**Economic Commission for Europe****Inland Transport Committee****World Forum for Harmonization of Vehicle Regulations****Working Party on Passive Safety****Sixty-first session**

**Regulation No. 14 (Safety-belt anchorages)****Proposal for the 08 series of amendments to Regulation  
No. 14 (Safety-belt anchorages)****Submitted by the expert from the International Organization of Motor  
Vehicle Manufacturers \***

Model A

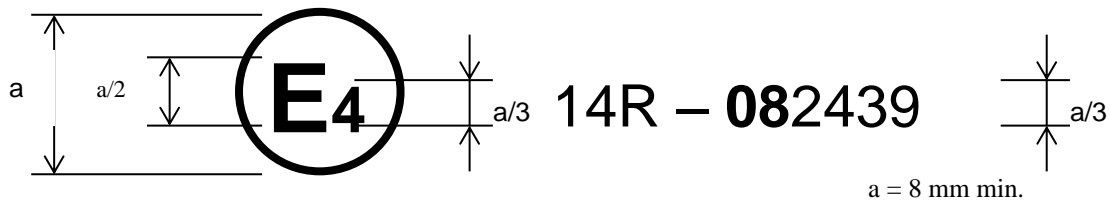
The above approval mark affixed to a vehicle shows that the vehicle type concerned has, with regard to safety-belt anchorages, been approved in the Netherlands (E 4), pursuant to Regulation No. 14, under the number ~~072439~~ **082439**. The first two digits of the approval number indicate that Regulation No. 14 already included the ~~07~~ **08** series of amendments when the approval was given.
